**Airworthiness  
Directive  
1993-001/3**

**L`Hotellier ball and socket connectors**

**Effective Date: April 09, 1998**

L`Hotellier ball and socket connectors with lock plates if installed in sailplanes, powered sailplanes and aeroplanes

#### **L'Hotellier ball and socket connectors with lock plate**

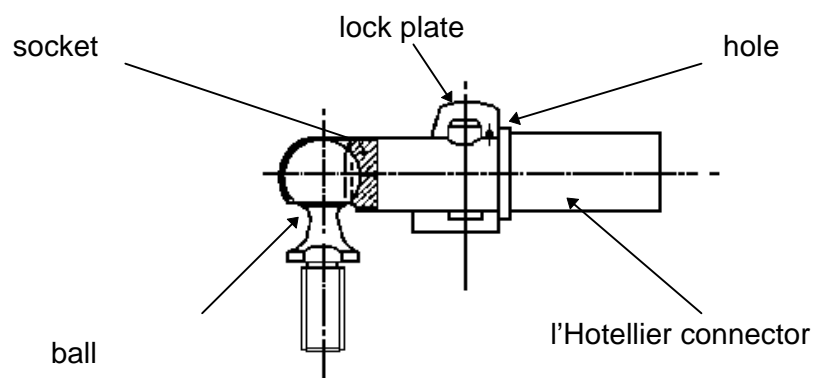
If the connectors are not yet equipped with safety pins (e.g. l'H 140-31 made by Hotellier), these safety pins have to be retrofitted. In certain cases it may become necessary to rebores the hole in the lock plate, which is provided for visual inspection, to  $\varnothing 1.2$  mm so that the safety pin can be inserted.

Unsecured ball and socket connectors may open automatically in flight!

1. Safety pins (e.g. L`H 140-31 made by Hotellier), have to be retrofitted, if not yet installed. In certain cases, it may become necessary to rebores the hole in the lock plate, which is provided for visual inspection, to  $\varnothing$  1.2 mm so that the safety pin can be inserted (see attachment section I).

#### LBA-approved locking systems

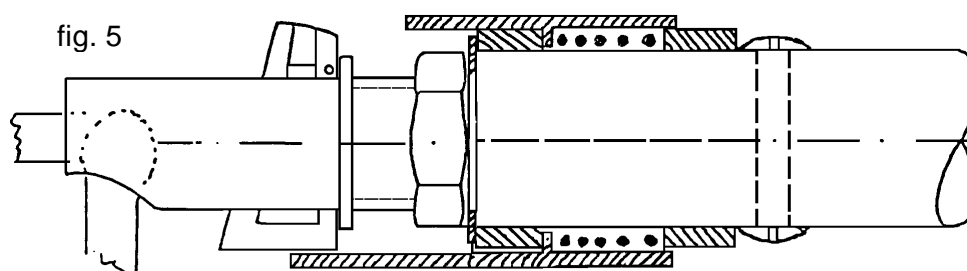
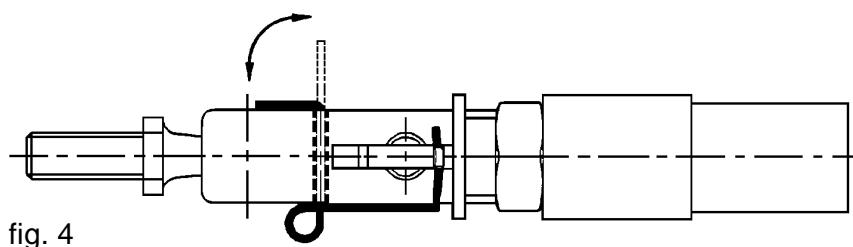
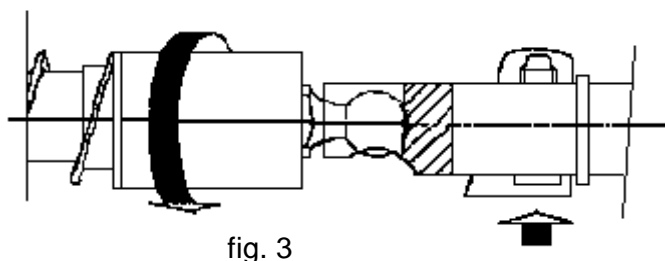
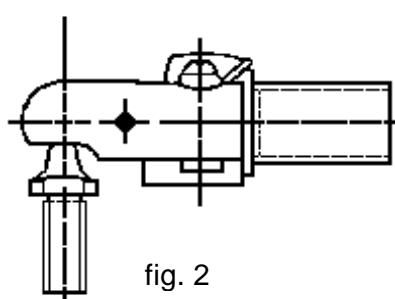
The following systems to secure L'Hotellier ball and socket connectors are LBA-approved: Uerlings sleeves or Uerlings type sleeves (see section III), safety pin (figures 2 and 2a), LS-safety sleeve (figure 3), Schempp-Hirth spring (figure 4) and Wedekind locking system (figure 5).

The use of a safety pin can be waived if the L`Hotellier ball and socket connector is already equipped with an approved locking system (e.g. Uerlings type sleeve, LS locking sleeve, Schempp-Hirth spring or Wedekind locking system) or if such a system is to be installed.

**Installation instruction for Uerlings type sleeves**

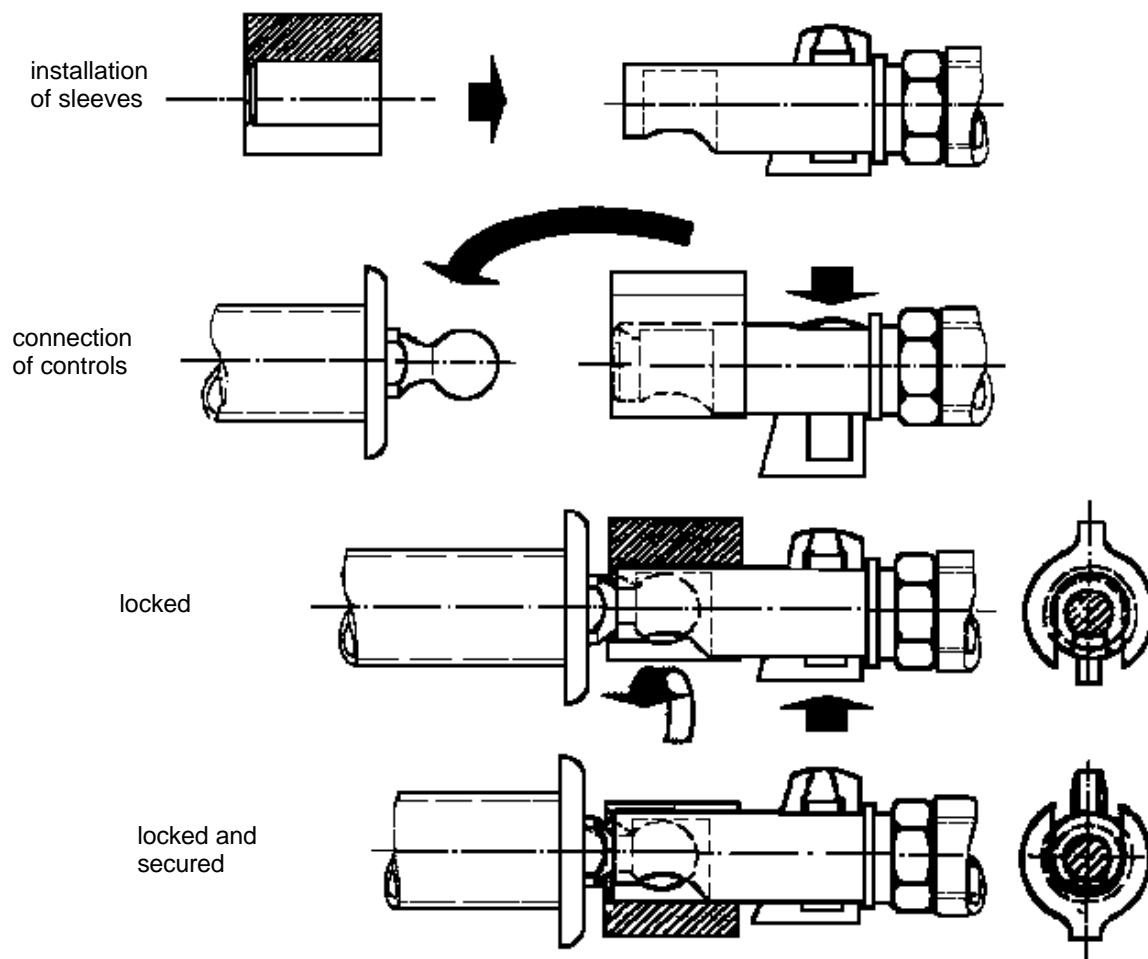
They may by no means be clipped radially onto the l'Hotellier ball and socket connector. Radial clipping (excessive opening of the sleeve) may lead to cracks or ruptures due to overstressing so that the sleeve cannot function properly any more.

For installation, the sleeves have to be slid axially onto the l'Hotellier ball and socket connectors.

**L'Hotellier ball and socket connectors**

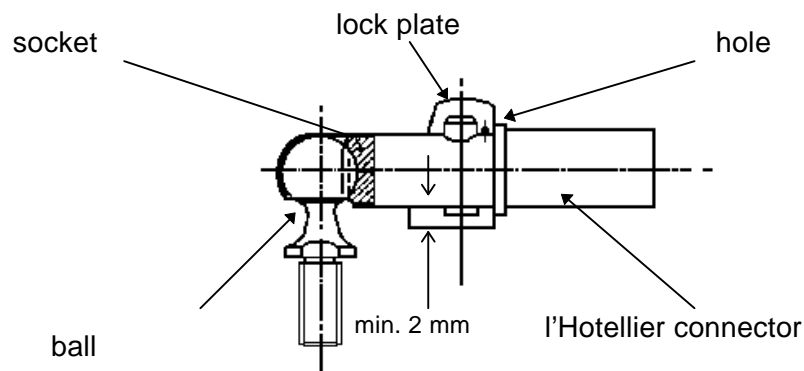
The socket is to be slid completely over the ball with the lock plate pressed down. During locking the lock plate moves back slightly so that in a correct connection the hole on the narrow edge of the lock plate becomes visible.

The safety pin is to be inserted in this hole thus securing the ball and socket connector.

By loading the connection full engagement of the ball is to be verified!
